ERRATA FOR IEEE 1394b THREE-PORT CABLE TRANSCEIVER/ ARBITER TSB81BA3, TSB81BA3I (SLLS559) AND TSB81BA3-EP (SGLS194)

SLLZ015C – DECEMBER 2002 – REVISED MARCH 2006

TSB81BA3 Silicon Errata

This document contains corrections and additions to the following device data sheets: TSB81BA3 (TI Literature Number SLLS559) and TSB81BA3-EP (TI Literature Number SGLS194).

Figure 1. BOSS Arbitration Issue Caused By Mixed Cable Lengths

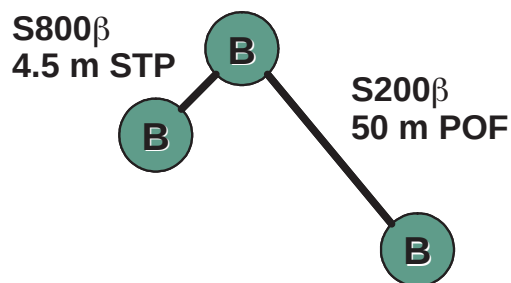
2. BOSS arbitration issue	<u>Symptom</u> A bus-reset may occur in certain topologies when 1394b BOSS arbitration is in use. <u>Occurrences</u> This issue is only possible if three or more BOSS-arbitration capable nodes are connected through a 1394b connection. To be BOSS-arbitration capable a node must have a 1394b PHY and a 1394b Link using the 1394b PHY-Link interface connection. If a narrow timing window is violated (dependent on cable lengths and/or mixed speed bus hops) a middle node may detect a packet collision, causing a PHY state timeout. The state timeout causes a bus reset. Repetitive occurrences result in repetitive bus resets. <u>Example Topologies</u> A. Mixing short and long cable lengths. A BOSS arbitration issue may occur in the middle node. Figure 1 shows an example topology that would exhibit the condition.	A. Use one or more 1394a link-layer controllers (LLCs). If the network only consists of nodes using 1394a link layers, then BOSS arbitration is not utilized; Gap_Count delays are maintained and therefore nodes are not affected by this errata. B. In nodes that do not have a link, disable BOSS arbitration (e.g., force the BMODE pin to the logic 0 state). C. Use a topology where all nodes use the same 1394a compatible bus speed (e.g., S400) and at least one IEEE Std 1394a-2000 node is present. D. Use a topology where all 1394B nodes are at the same 1394b bus speed, using matched cable lengths between 1M and 4.5M.

Figure 2. BOSS Arbitration Issue Caused By Mixed Bus Hop Speeds

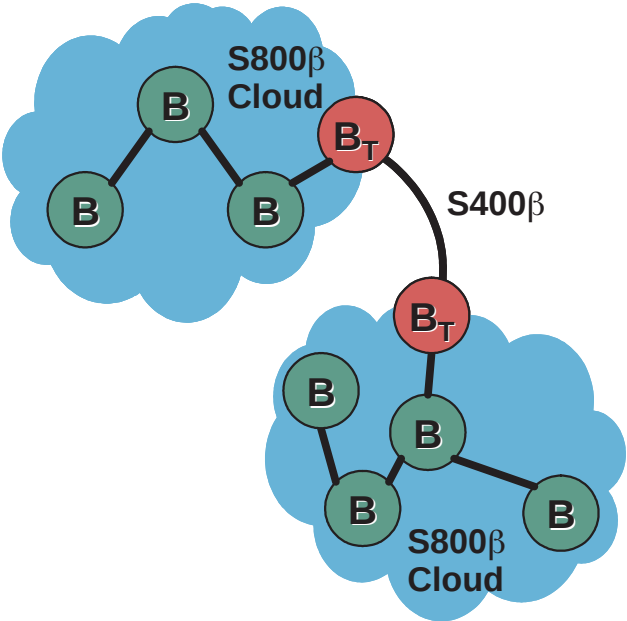
SILICON ERRATA ID	PROBLEM DESCRIPTION	RESOLUTION / WORK-AROUNDS
2. BOSS arbitration issue (continued)	<u>Example Topologies</u> (continued) B. Mixing bus hop speeds. Either transition node (B _T) may have a BOSS arbitration issue. See Figure 2.

Figure 3. BOSS Arbitration Issue—Detailed Example Situation

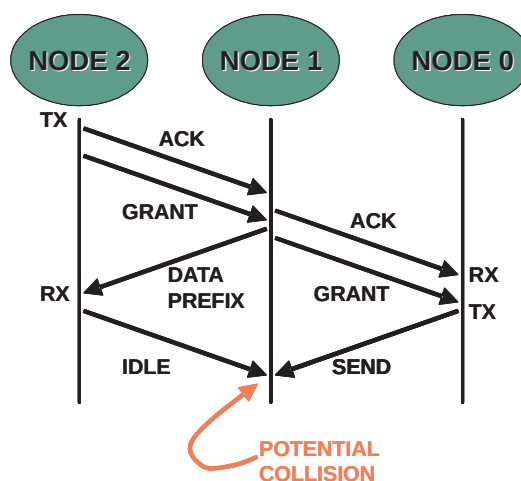
SILICON ERRATA ID	PROBLEM DESCRIPTION	RESOLUTION / WORK-AROUNDS
2. BOSS arbitration issue (continued)	<u>Detailed Example Situation</u> See Figure 3. - Node #2 transmits a high-speed packet that ends an Async subaction or the Isoch period. - Node #2 advances the Async phase (no requests pending for the current phase). - Node #0 has a bus request pending for the new phase. - Node #2 sends an Async grant. - The Async grant is forwarded through a senior node (Node #1) and down through a junior connection to Node #0. - If a narrow timing window is violated the middle node (Node #1) will detect a packet collision, causing a state-timeout while forwarding the grant to the next node. The state-timeout will cause a bus reset.
